54 / NHTSA 14V-487

# U.S.A. RECALL CAMPAIGN NO. 54

## Ferrari 458 Italia and 458 Spider Vehicles

### Update of Front Hood Latch

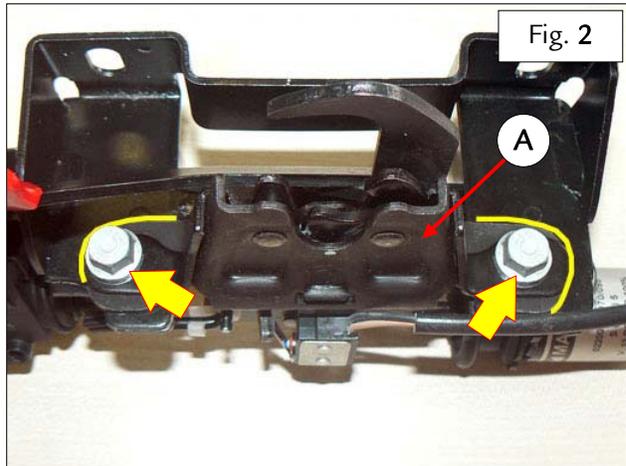
1. Disconnect the battery (as described in Paragraph F2.01 - step 4 of the Workshop Manual).
2. Remove the luggage compartment liner (as described in paragraph E4.07 - step 5 of the Workshop Manual).
3. Remove the retainer ring indicated by the arrow - Fig. 1.
4. Detach the Bowden cables (1) from the relative retainwe pin on the lock (A) - Fig. 1.

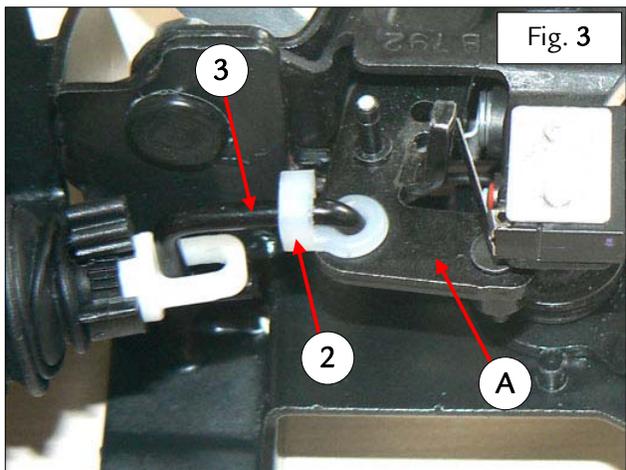
5. Mark the position of the lock (A) relative to the mount, as shown in the photo aside, to facilitate subsequent reassembly – Fig. 2.
6. Undo the nuts shown – Fig. 2.

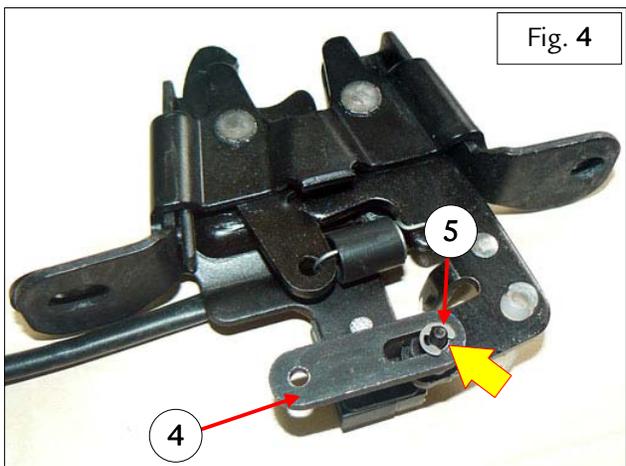
7. Release the stop (2) from the hook (3) – Fig. 3.
8. Remove the hook (3) from the lock (A) – Fig. 3.
9. Lift and tilt the lock (A) as much as possible, to allow access to the bottom side – Fig. 3.

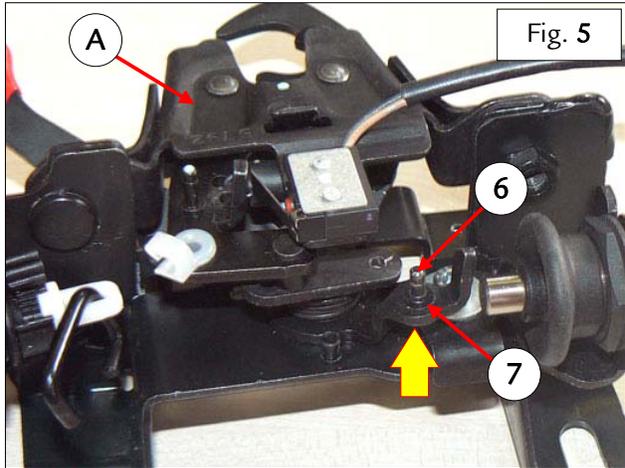
10. Fit the link rod **Part No. 67012800** (4) onto the indicated pin on the lock, and then fasten by fitting the retainer ring **Part No. 11087476** (5) – Fig. 4.  
**Note:** fasten the link rod (4) to the lock on the slot side, as shown in the photo aside.

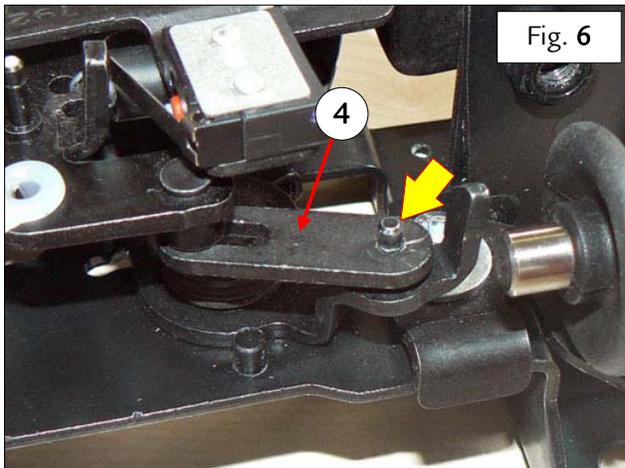
11. Fit the lock (A) in the relative seat – Fig. 5.
12. Fit the pin (6) and then the spacer (7) through the hole in the bracket – Fig. 5.

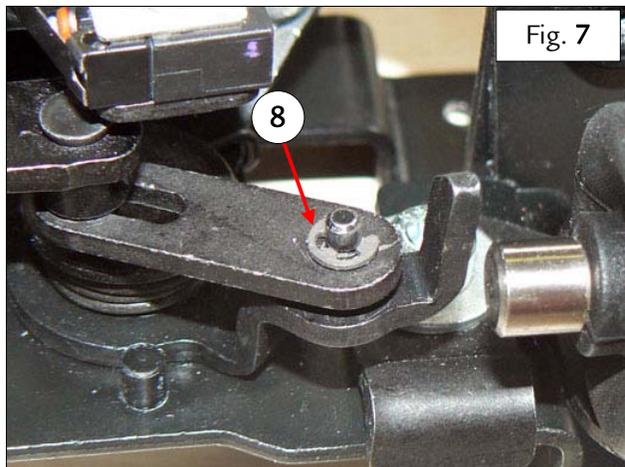
13. Align the link rod (4) with the pin indicated by the arrow – Fig. 6.

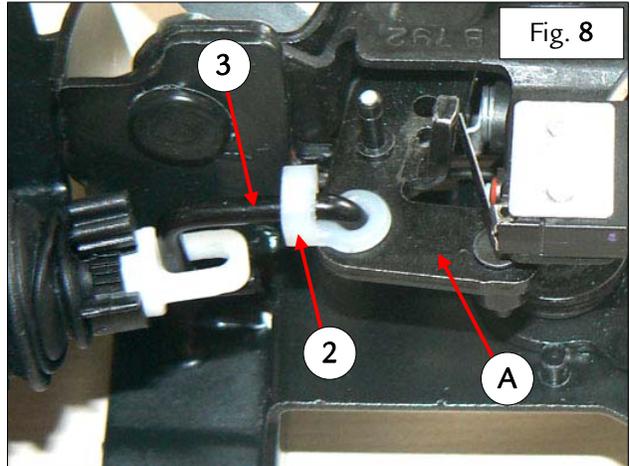
14. Install the retainer ring Part No. 11087476 (8) – Fig. 7.

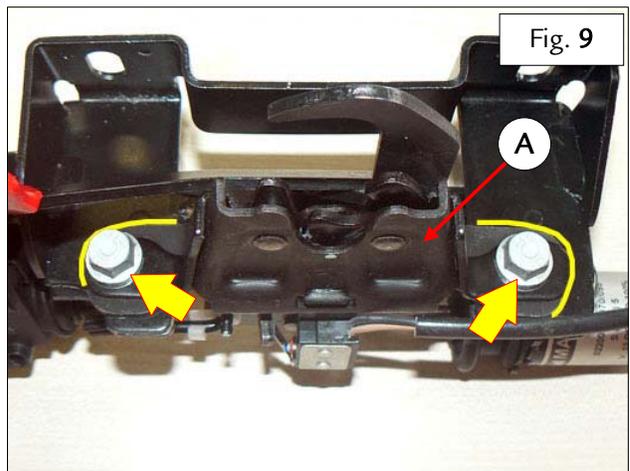
15. Fit the hook (3) in the relative seat on the lock (A) - Fig. 8.
16. Fasten the stop (2) on the hook (3) - Fig. 8.

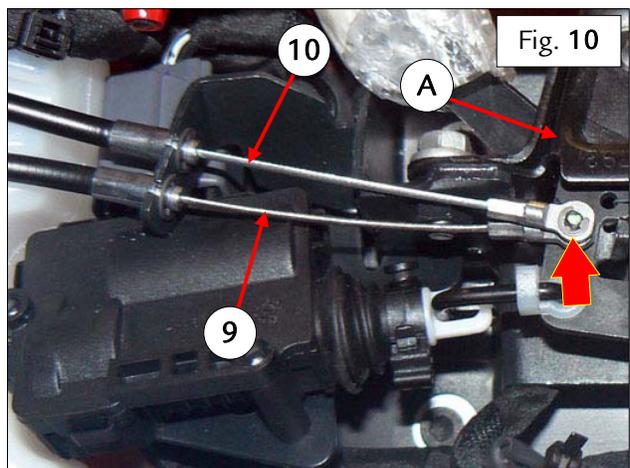
17. Align the lock (A) correctly, using the markings made during removal as reference - Fig. 9.
18. Fit and tighten the screws indicated by the arrows to the torque of 6.63 ft. lbs. (9 Nm) class B - Fig. 9.

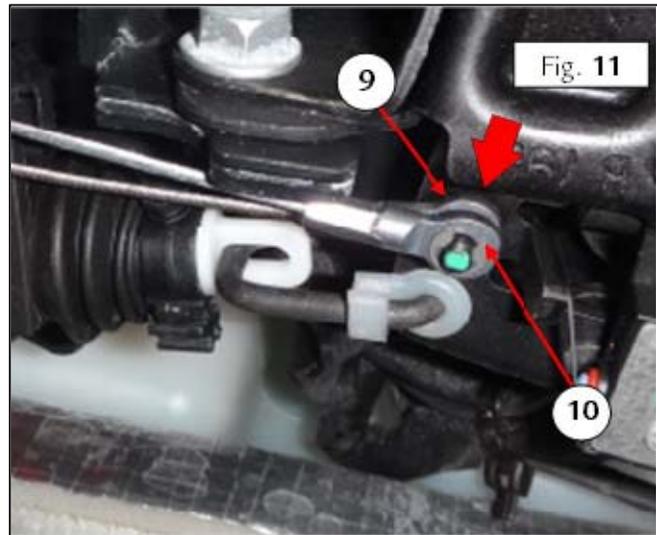
19. Fasten the the terminals of the emergency release cables (9) and (10) to the pin on the lock (A) indicated by the red arrow, fitting the terminal of cable (9) first and then the terminal of cable (10), then fasten the assembly with a new retainer ring Part No. 11087476 - Fig. 10.

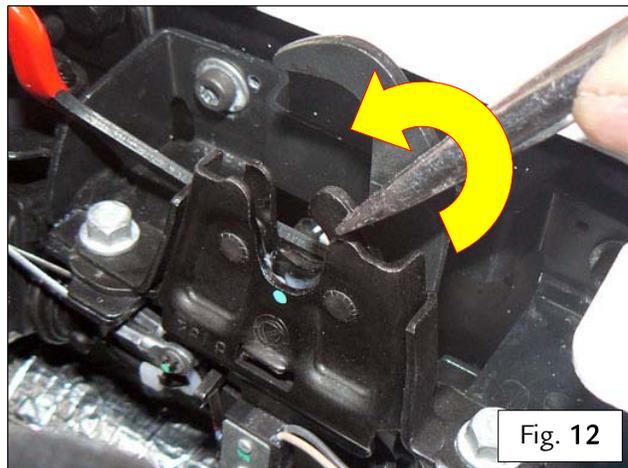
20. Ensure that cable (9) is fitted on the pin **first** and then cable (10) before securing the cables with the relevant retainer ring – Fig. 11.
